## **Park Point Beach House**

Accessibility Review

City of Duluth, MN

### Park Point Beach House

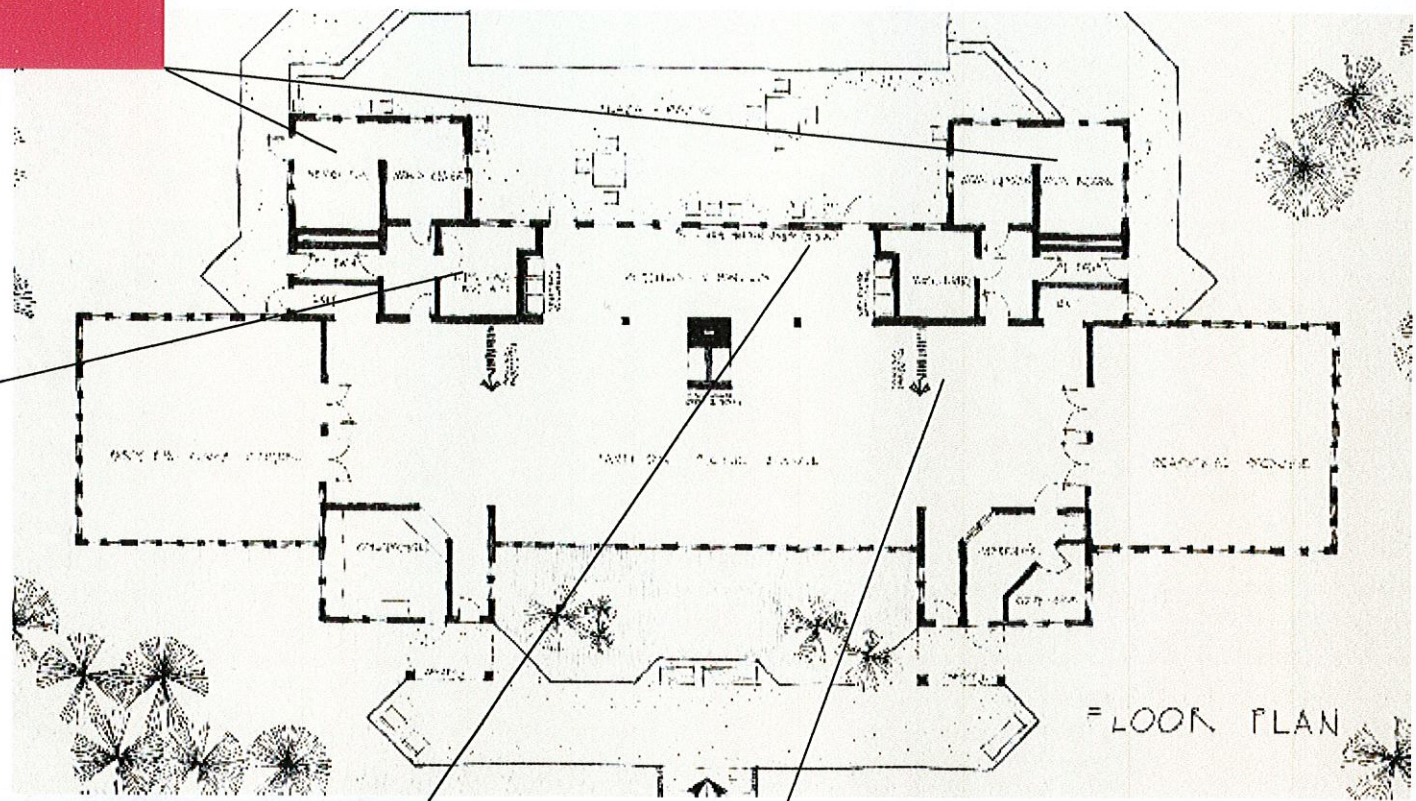
- Add a raised and braille sign
- Re-hinge door to provide maneuvering clearance
- Insulate pipes at lavatory
- Add pulls to accessible stall door
- Add a full height mirror
- Lower the towel dispenser
- Create a 60" wide accessible stall
- Replace grab bars

Widen door

Modify double doors to provide 32" clear opening

Lower a section of the concession counter

Install door lever hardware
